**ADDENDUM NO. 1 for UNL Invitation No. 2309-14-7200**  
**Addendum 5 for overall project**

**PROJECT NAME:** Hamilton Hall Morin Lab Renovation  
**UNL PROJECT NUMBER:** C074P209

**ADDENDUM NO. 5**

SO. JAMB OF DOOR 405

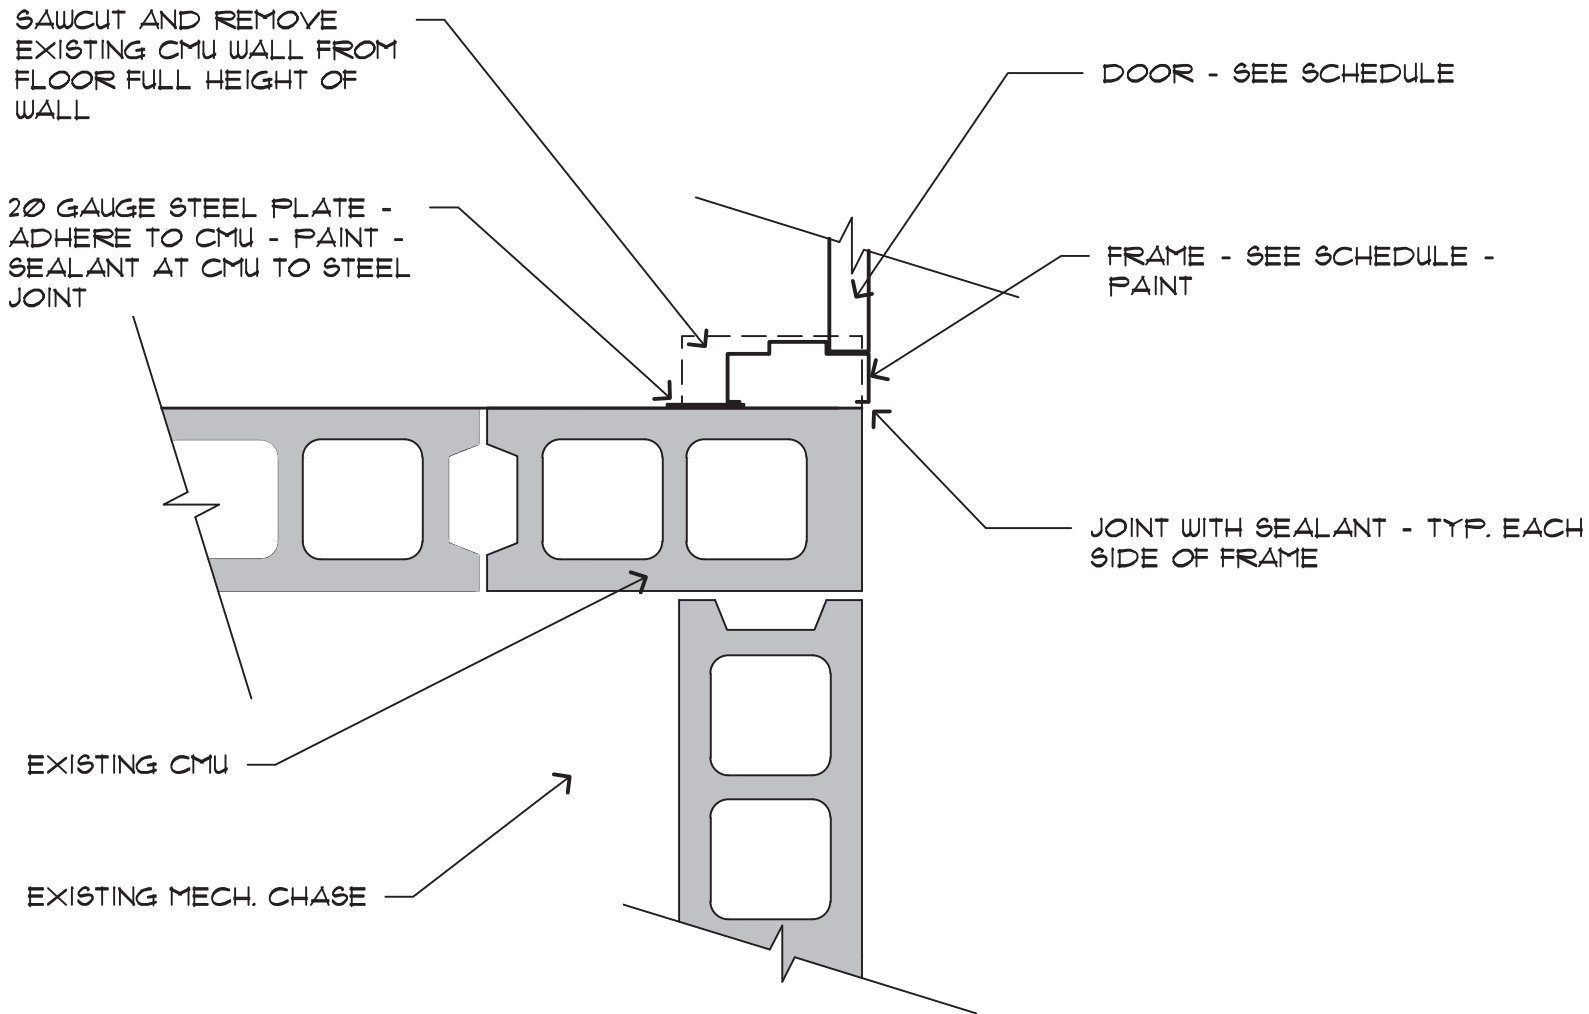
- a. At door 405, include a note to sawcut and remove the +/- 3-1/4" long CMU wall at the south jamb and slide the door and frame 3" south so the south jamb is at the north face of the north mechanical chase wall. Cut the CMU flush with the north face of the north mechanical chase wall. See attached detail 10 for sheet A3.1.

- b. Include a note to add a 20 gauge flat plate at the west side of the south jamb to conceal the cut CMU as shown on the attached detail. Include sealant at the joint between the plate and the CMU wall and paint the plate to match the CMU. Ease the exposed plate edge. See attached detail 10, for sheet A3.1.

# 9 NO. JAMB OF DOOR 405

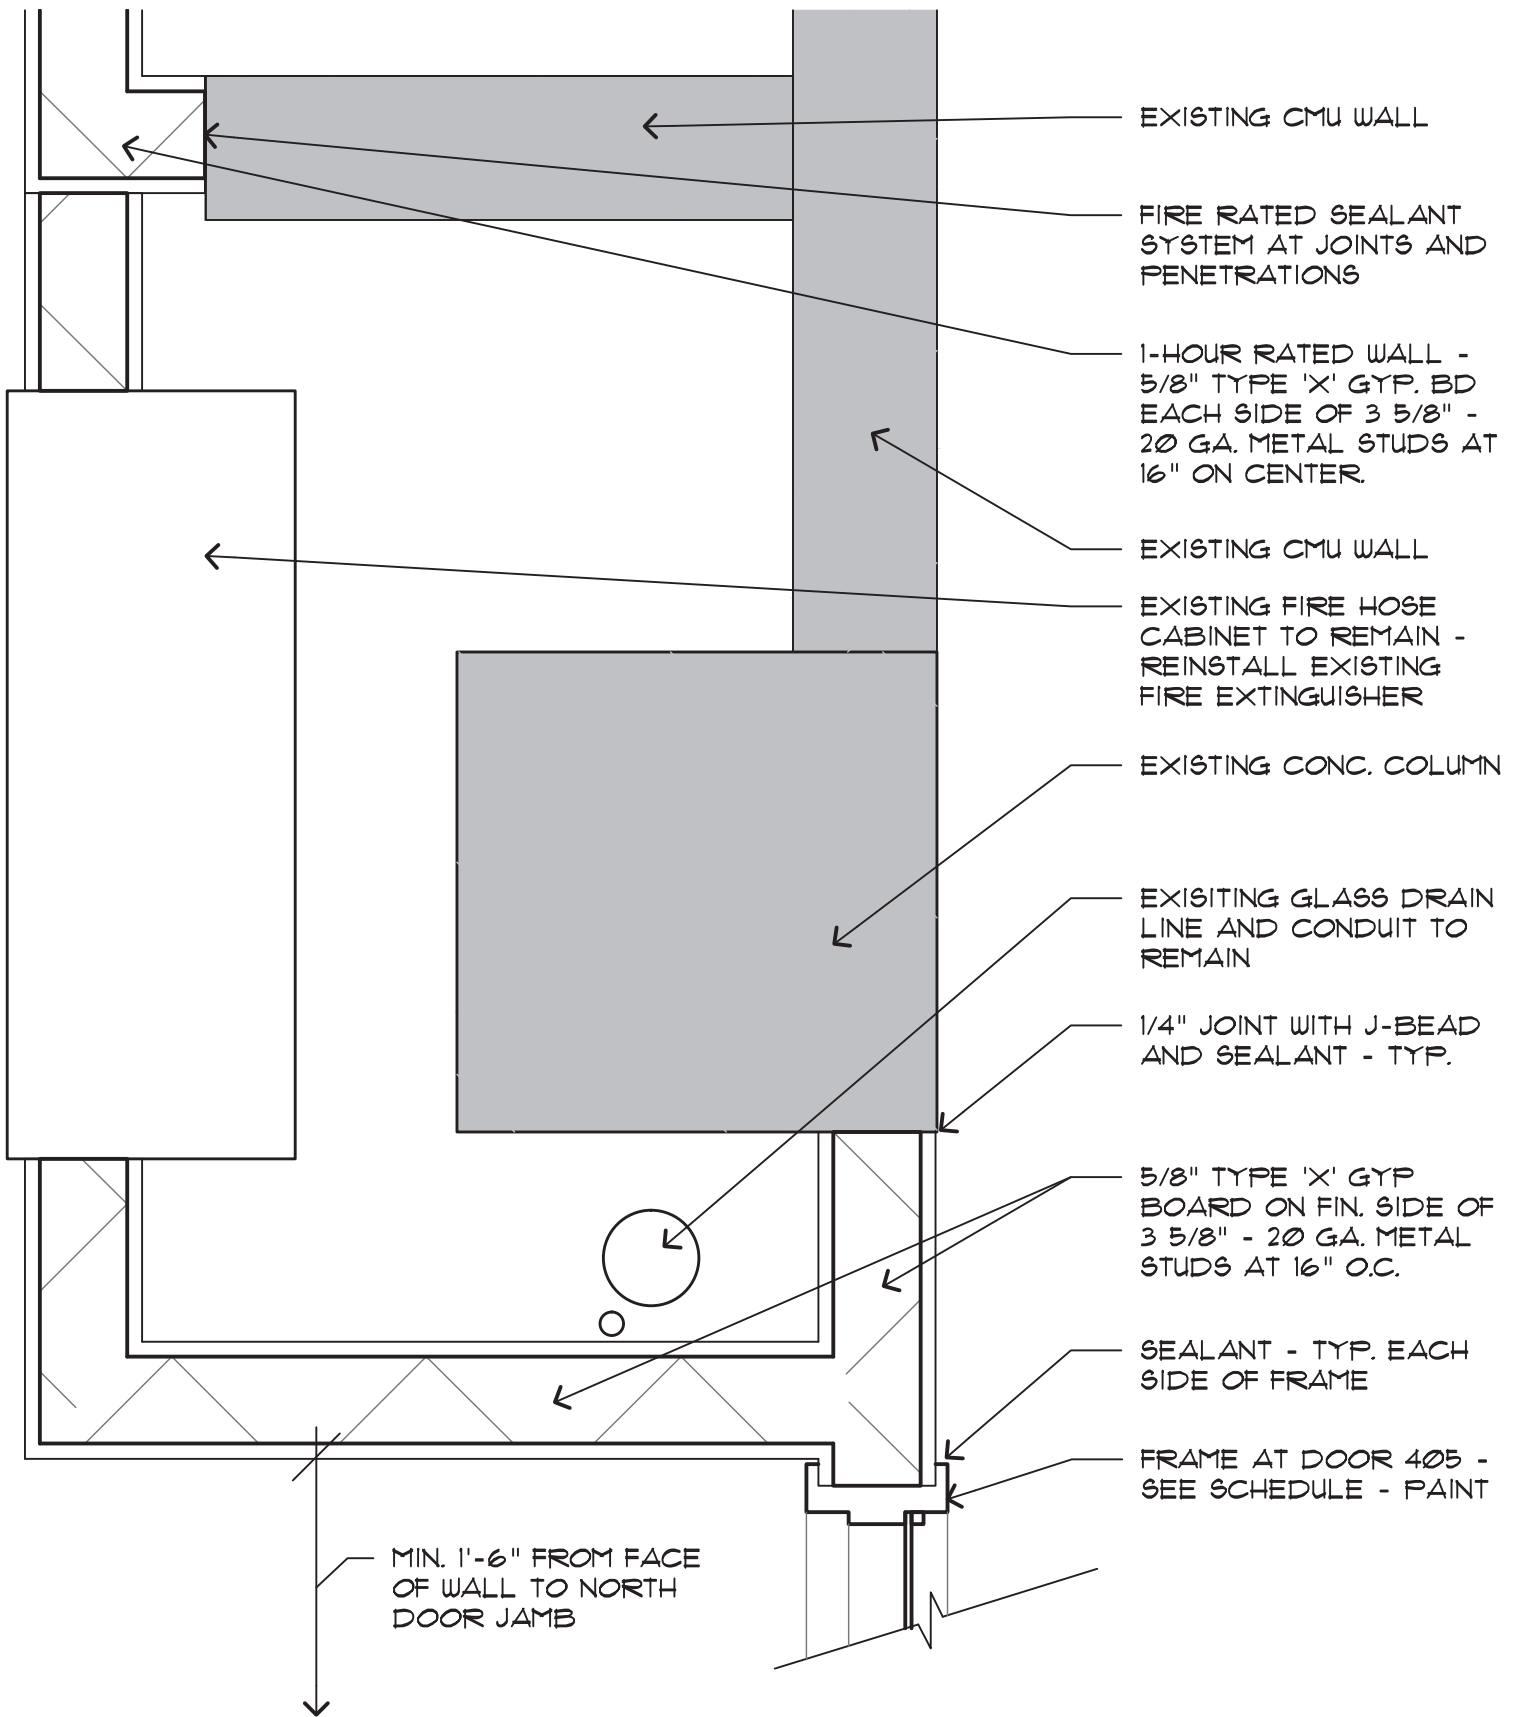
- c. At the north jamb of door 405 sidelight, revise the wall from shaft-wall construction to 5/8" gyp on finished side of 3 5/8" – 20 ga metal studs. Shift the metal stud wall south to enclose the existing glass waste pipe within the chase. See attached detail 9, for sheet A3.1.

- d. Maintain minimum 18" clearance from the north door jamb to the gyp wall to the north.

# 4TH FLOOR PLAN - MECHANICAL (FOR REFERENCE ONLY)

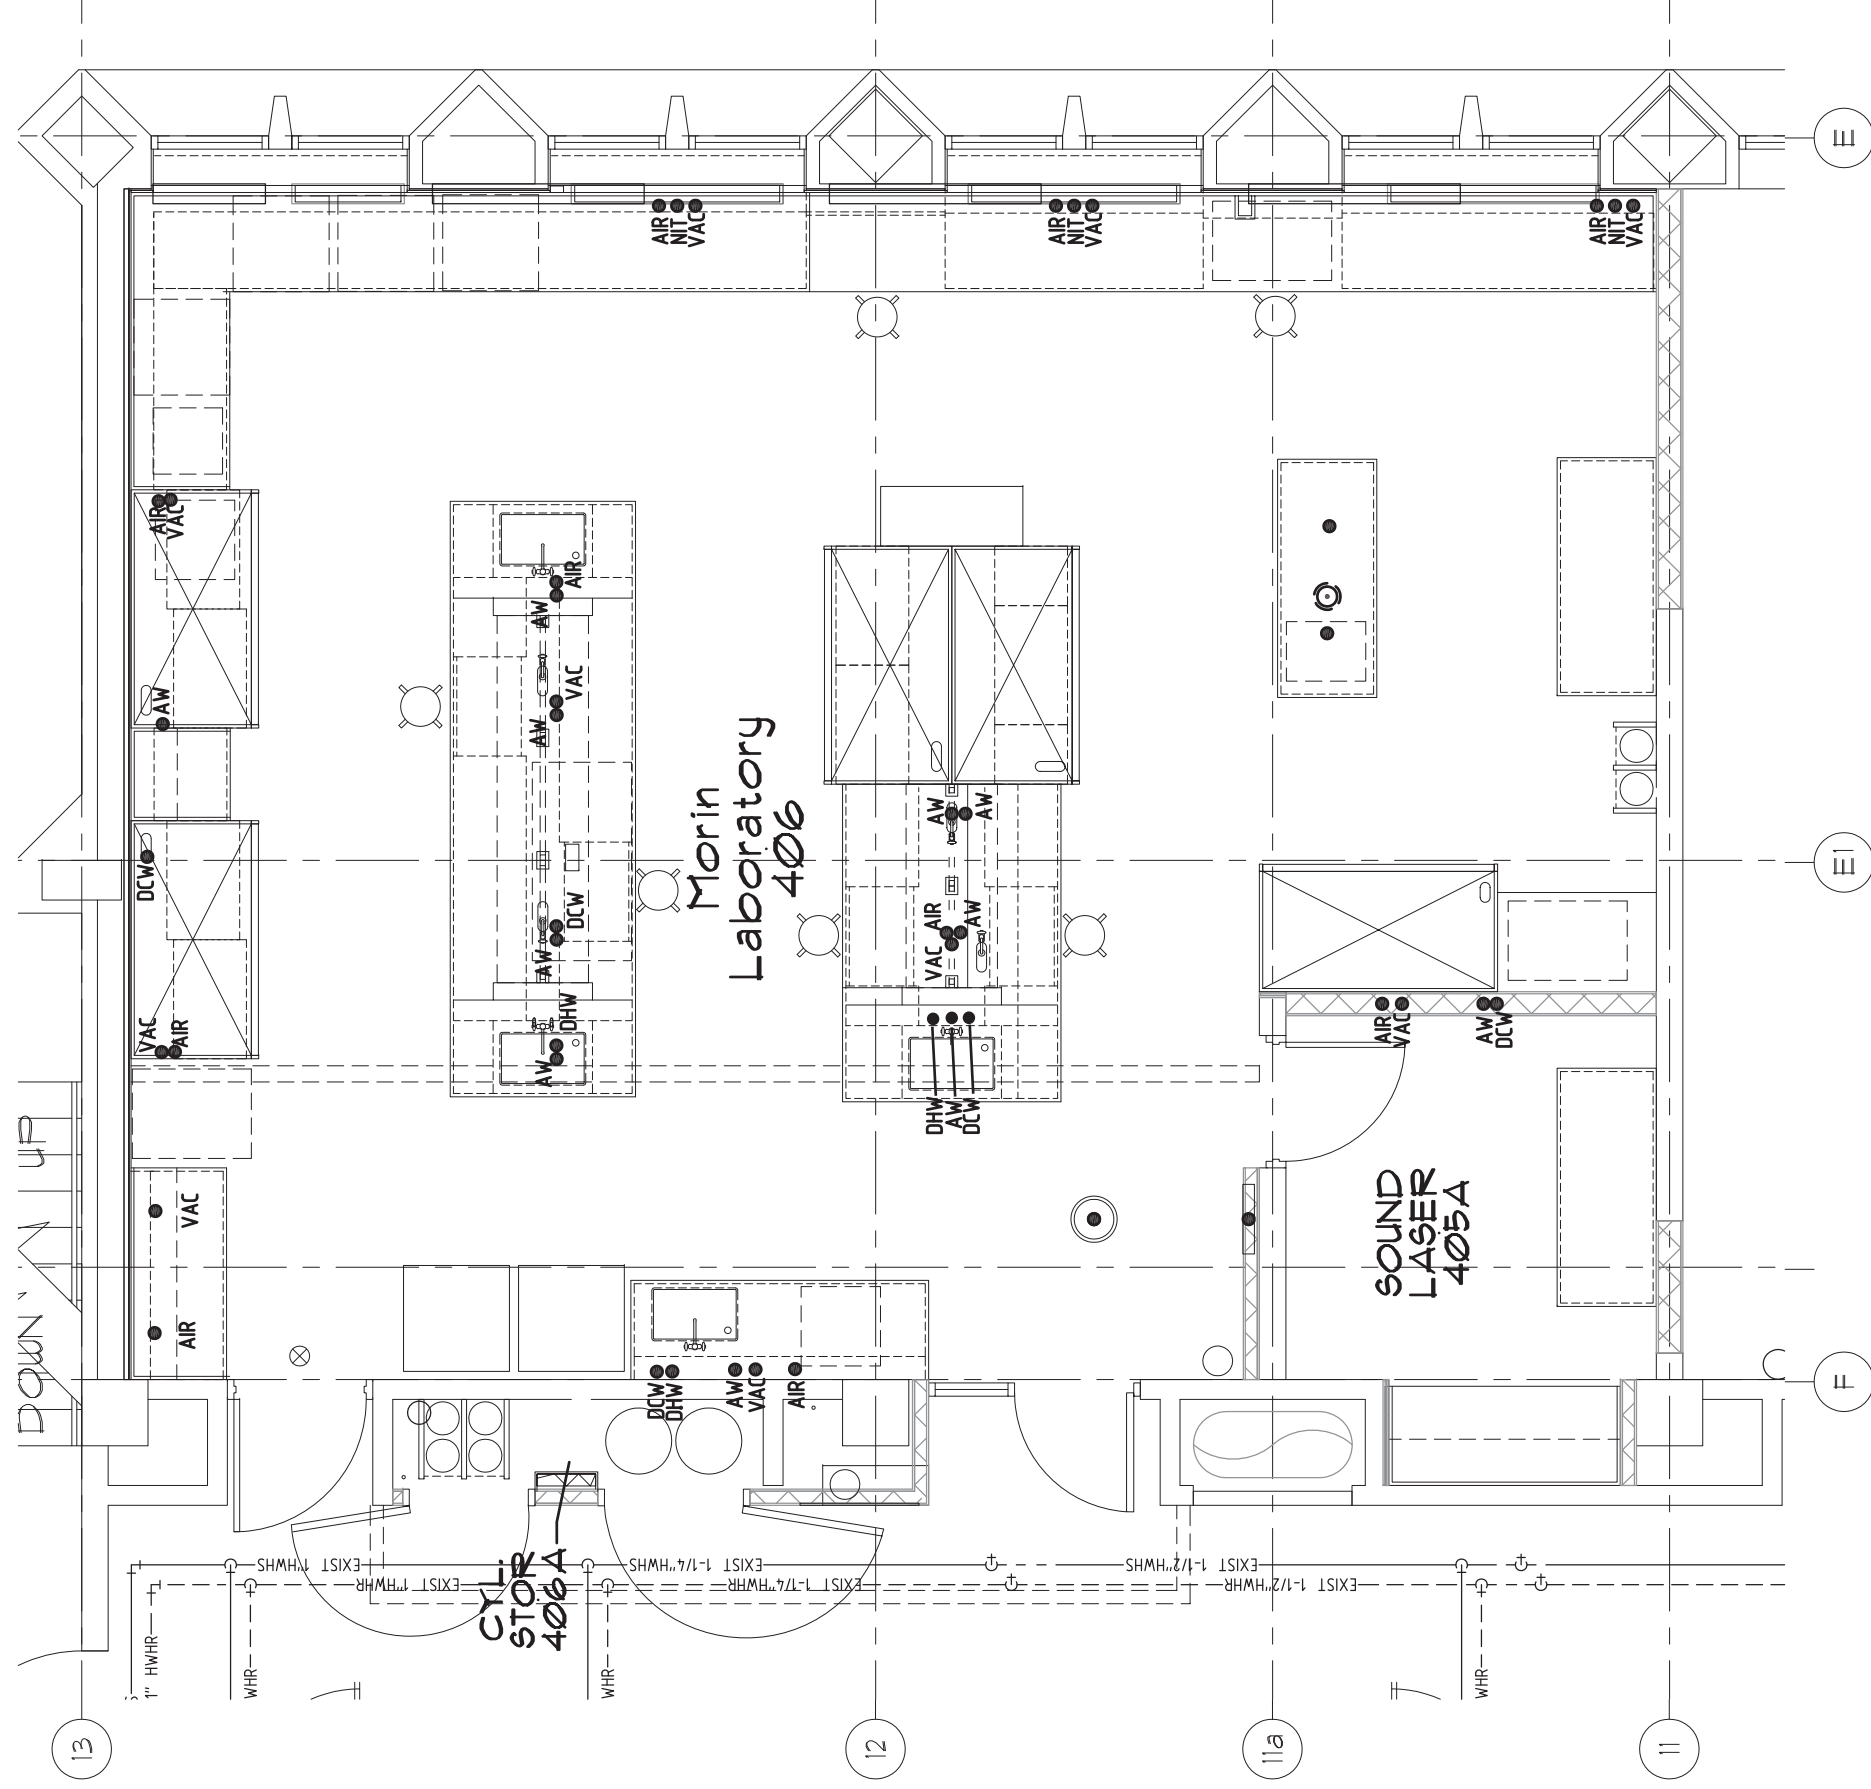
1. Key notes:
  - a. Key note 20 shall read "Location of mushroom head push button for emergency nitrogen and argon gas shutoff valve (see note 14). Provide two (2) permanent plastic sign noting "EMERGENCY NITROGEN & ARGON GAS SHUT-OFF" mounted above the push button at each of 2 locations.
  - b. Key note 12 shall read "Existing fire sprinkler cabinet shall remain and protected during all phases of the construction – do not provide a new cabinet".
2. Floor penetrations:
  - a. See attached plan for existing floor penetrations, solid round hatched circles are actual location of the floor penetrations. Contractor is responsible for horizontal piping from the stub up to the fixture. Horizontal piping shall be installed in cabinet piping chases.
